LAWRENCE HISTORIC RESOURCES COMMISSION
ITEM NO. 8: DR-9-151-11
STAFF REPORT

DR-9-151-11 900 New Hampshire St; New Construction; Certified Local Government Review, Certificate of Appropriateness Review, and Downtown Urban Conservation Overlay District Review. The property is in the environs of Lawrence's Downtown Historic District and the North Rhode Island Historic District, National Register of Historic Places and within the Downtown Urban Conservation Overlay District. It is also in the environs of the Shalor Eldridge Residence (945 Rhode Island), Register of Historic Kansas Places and the Social Service League (905-907 Rhode Island), Lawrence Register of Historic Places. Submitted by Micah Kimball of Treanor Architects for 9th & New Hampshire LLC, property owner of record.

The applicant is requesting to construct a new, 6-story, multi-use, 134,775 square foot building. It will contain a mix of hotel, apartment and commercial uses. The lot is currently vacant and is zoned CD.

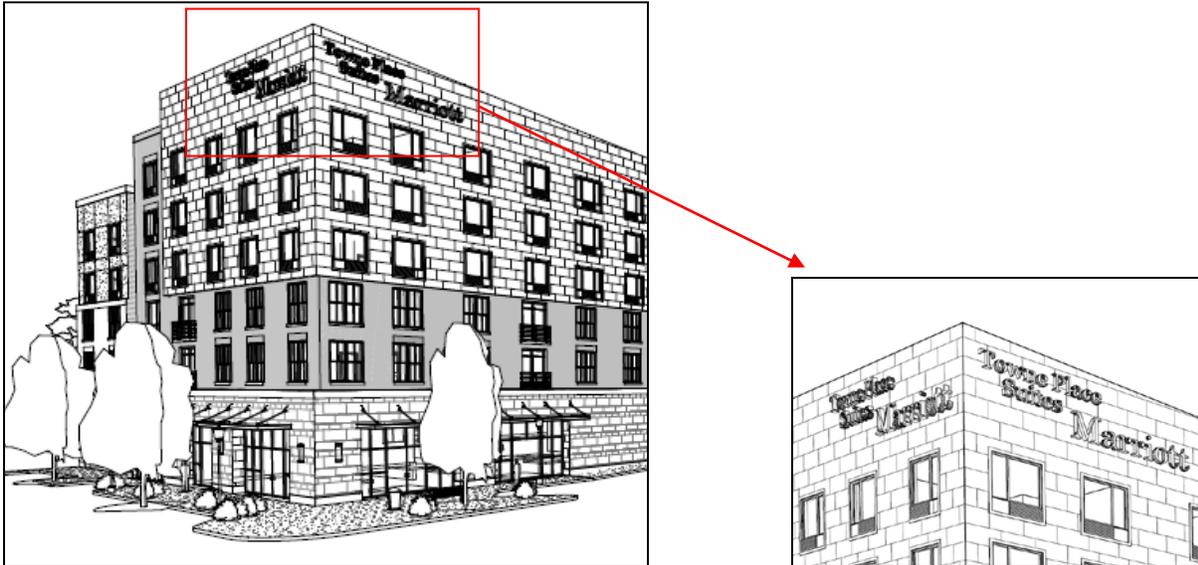
On the submitted plans, there are two primary signs. One is on each side at the top of the northwest corner, the other next to the lobby door on the southwest side. Within the Urban Conservation Overlay District, signs should focus on being pedestrian oriented and neither of the proposed signs are. The sign on the southwest corner (see below), though at a more compatible height, is only visible for a pedestrian walking north up New Hampshire.

The signs at the top of the northwest corner have no relationship to the pedestrian. Signage at the top of buildings is highly unusual for the downtown district unless it shows the date of construction. To relate to pedestrian scale, the sign should be shrunk in size and moved to the street level. The current placement of the sign on the upper corner adds emphasis to the height, which includes a parapet to accommodate the signage. This is one of the main concerns of staff. Moving the sign would allow for the overall height of the building to be reduced, reducing the impact on the historic district.

As proposed, the signage does not meet the Downtown Design Guidelines or support the pedestrian emphasis called for in the downtown business district.

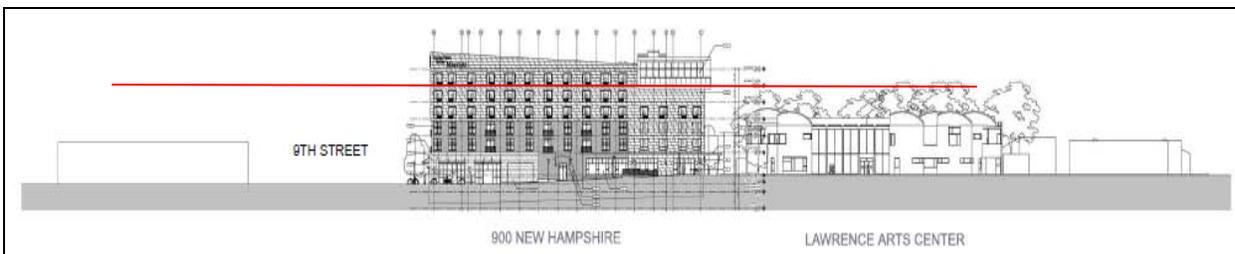
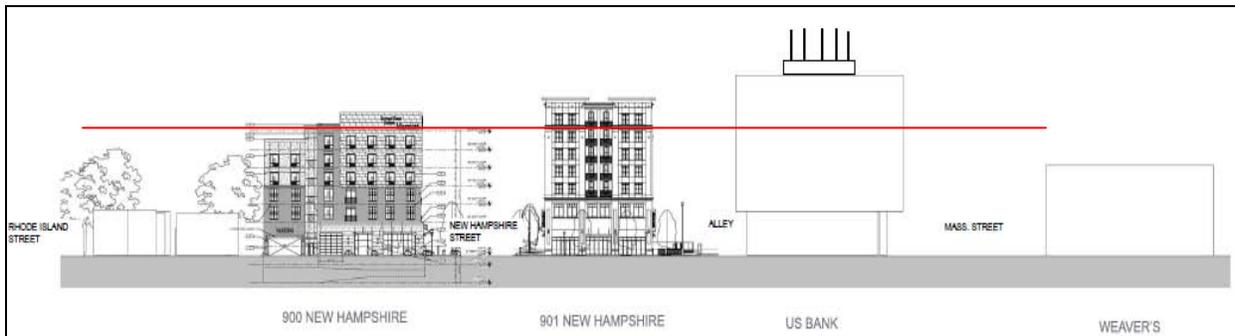
As seen from the scaled elevations below, 900 New Hampshire is much taller than its historic surroundings (approximately 69' with a 10' parapet). The guidelines emphasize consistency in the way new infill relates to the size of buildings around it whether they are historic or not. While this proposed project does relate to 901 New Hampshire and the US Bank building at 900 Massachusetts, those are modern buildings. The purpose of the guidelines is to maintain the overall character of the historic district and ensure responsibly designed development. How the project relates to one corner vs the entirety of two adjacent historic districts is important. The difference in height to the residential type structures that directly share an alleyway is of significant concern. The mixed use and high density are very desirable for the location but staff is of the opinion that a compromise in design can be reached.

The proposed project directly affects the spatial relationships of Lawrence's Downtown Historic District and the North Rhode Island Residential Historic District and does not ease the transition from commercial to residential, not meeting Standards #1 or #2;
